1 Rosser Street

**RE: 1 Rosser Street, Cottesloe**

# REVISED PLANS

PROJECT  
**PROPOSED GARAGE AND SHED**

TITLE  
**DECK LEVEL PLAN**

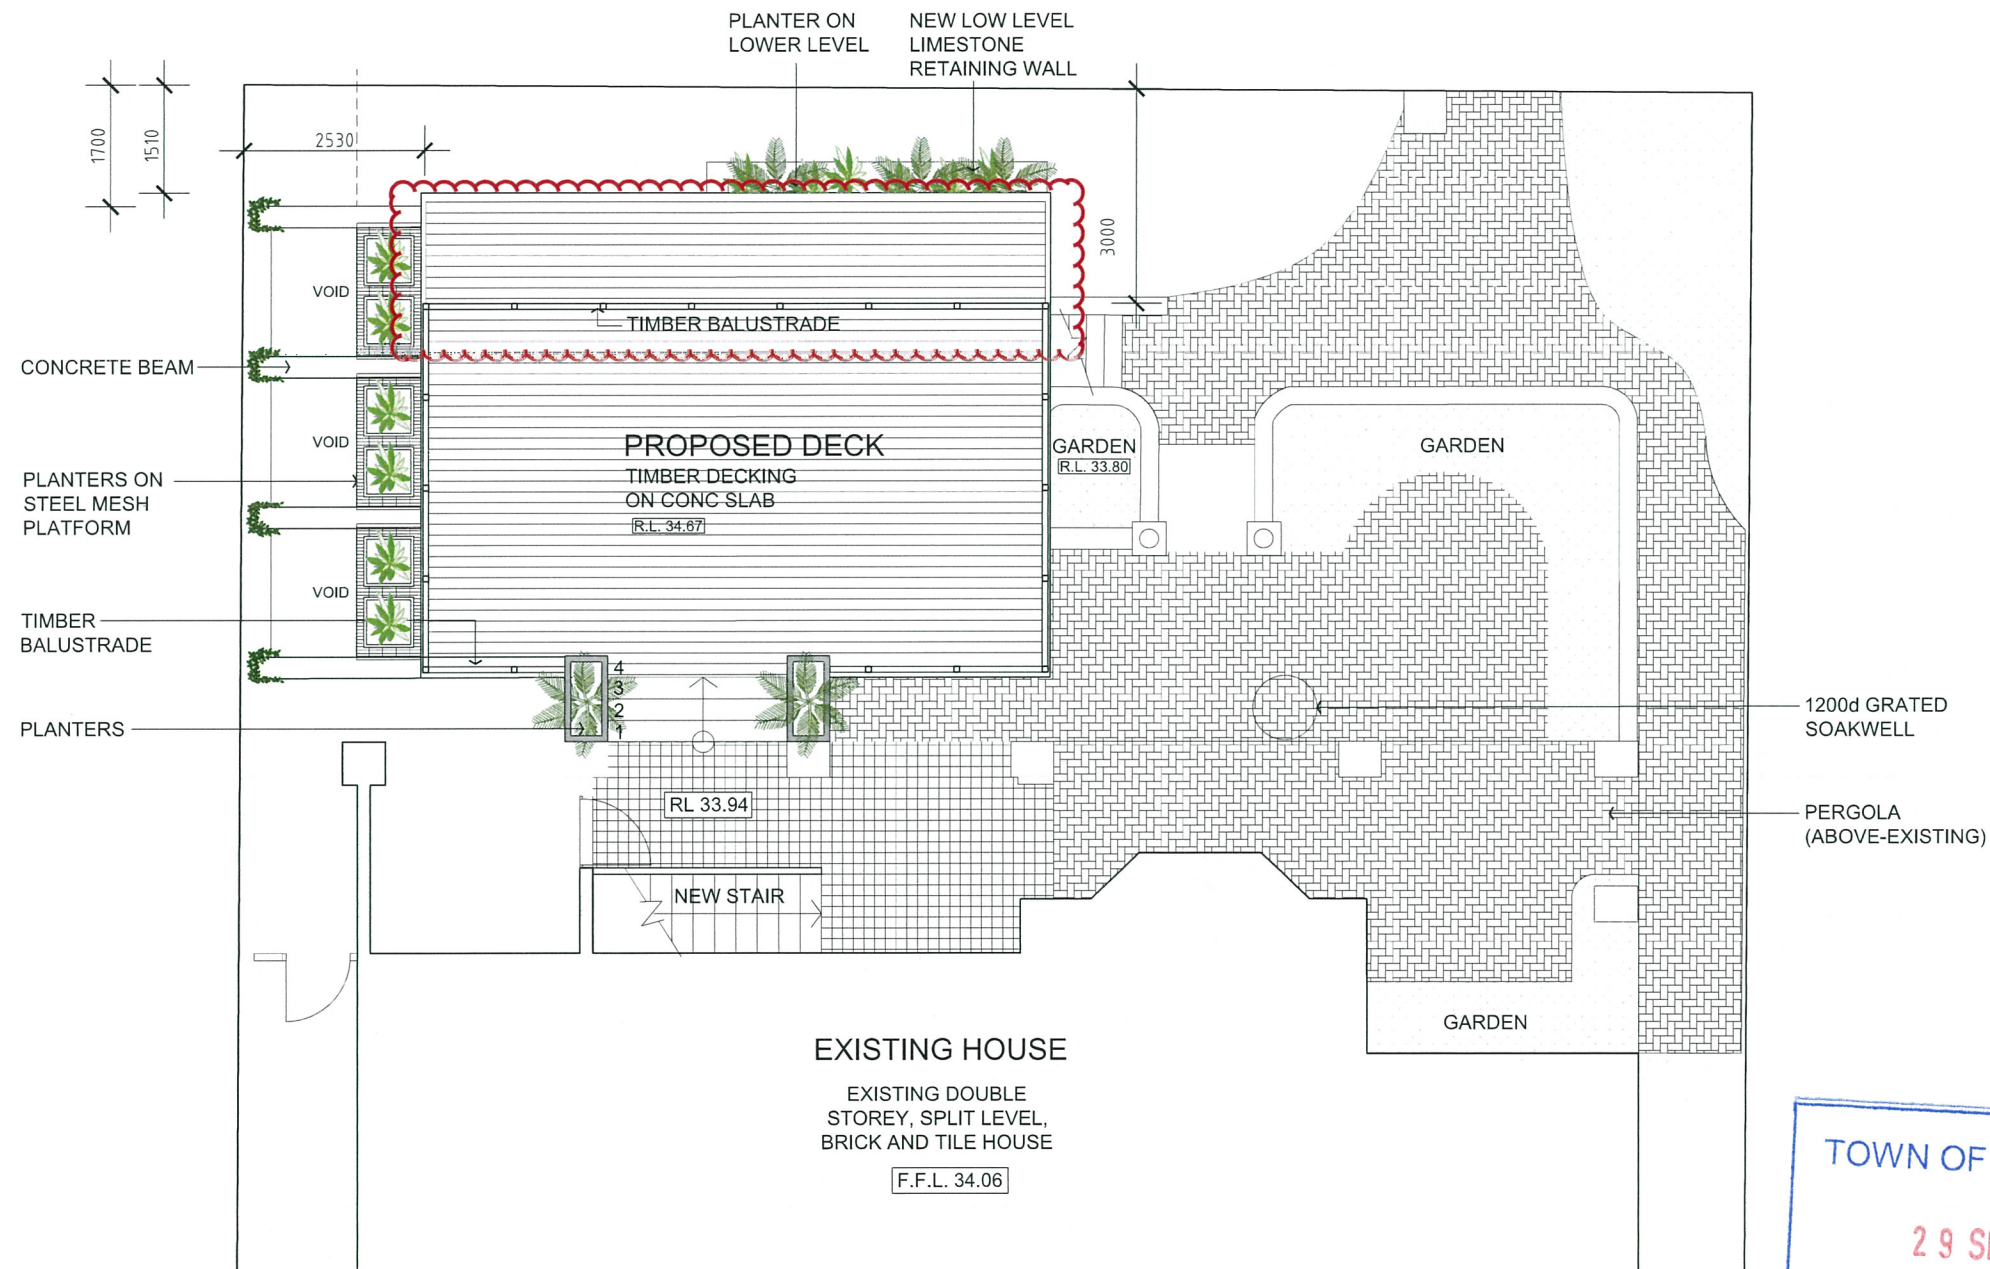
- Removal of planters from the northern edge of the garage roof.
- Reduce the height of the limestone planter box in front of the garage / carport.
- Further setback of balustrade to the deck so access is limited to no closer than 3.1m from the Rosser Street boundary.

REMOVAL OF PLANTERS FROM NORTHERN EDGE OF DECK, AND FURTHER SETBACK OF BALUSTRADE TO DECK

1 GARAGE FLOOR PLAN  
Scale: 1:50

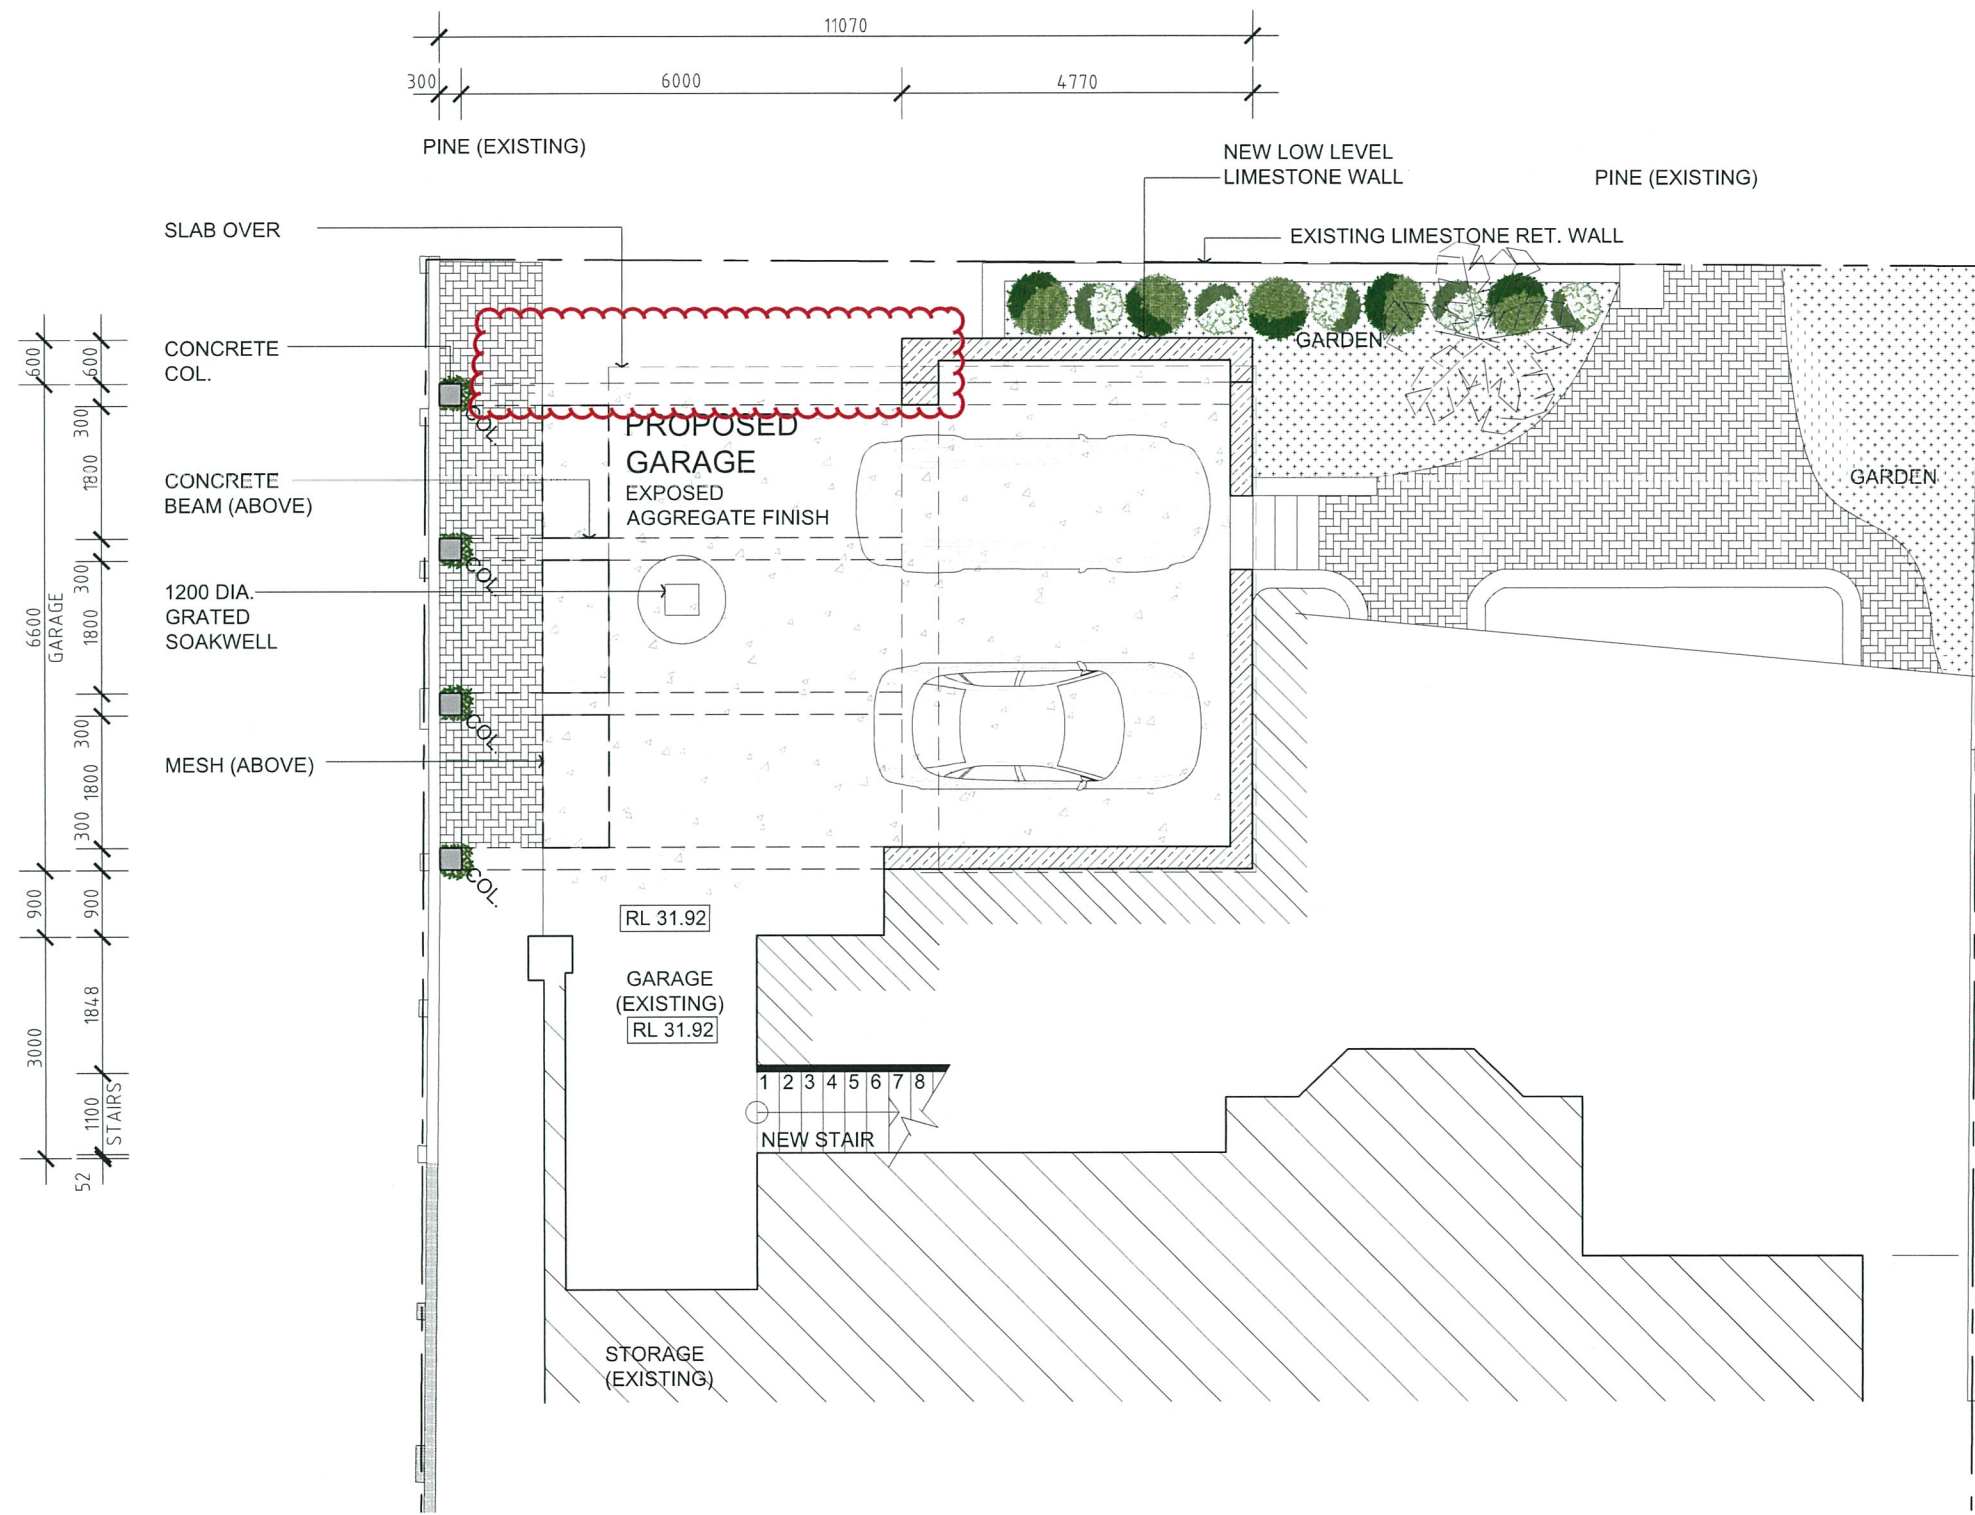
- Remove steel gates from the structure to increase transparency and further reduce perceived bulk
- Incorporate structural construction methodology for the roof and pergola to achieve visual outcomes that will minimise the perceived bulk and scale. At this phase of documentation we believe that concrete will provide the best result.

REMOVAL OF STEEL GATE TO CARPORT

**NORTH ELEVATION**  
SCALE 1:100

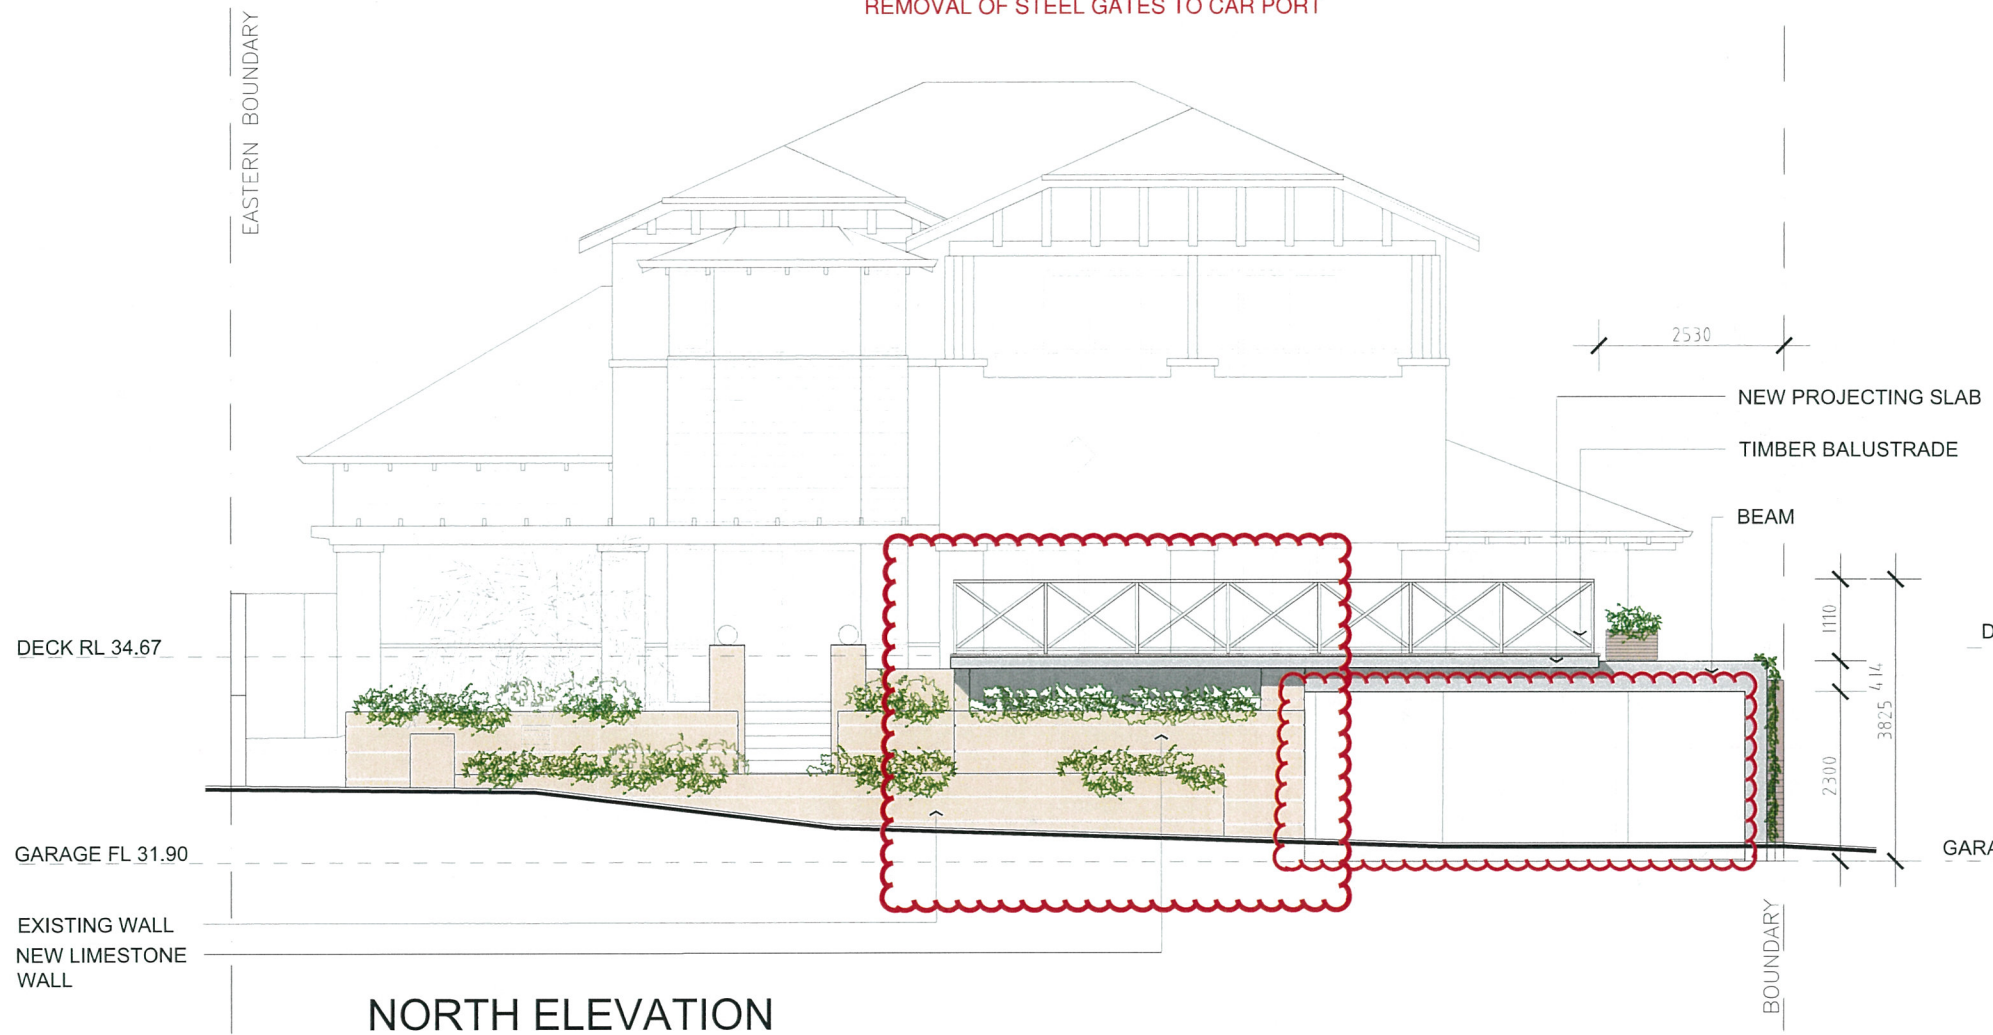
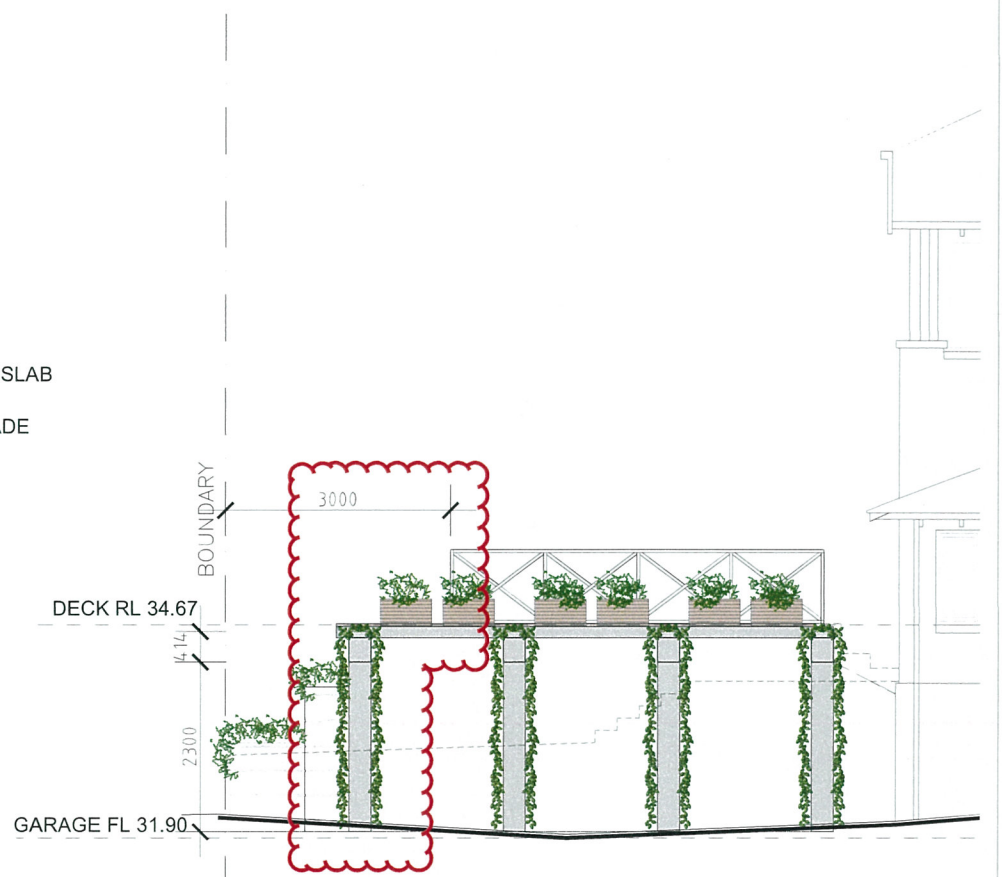
REDUCED HEIGHT OF LIMESTONE PLANTER BOX IN FRONT OF CAR PORT,  
REMOVAL OF STEEL GATES TO CAR PORT
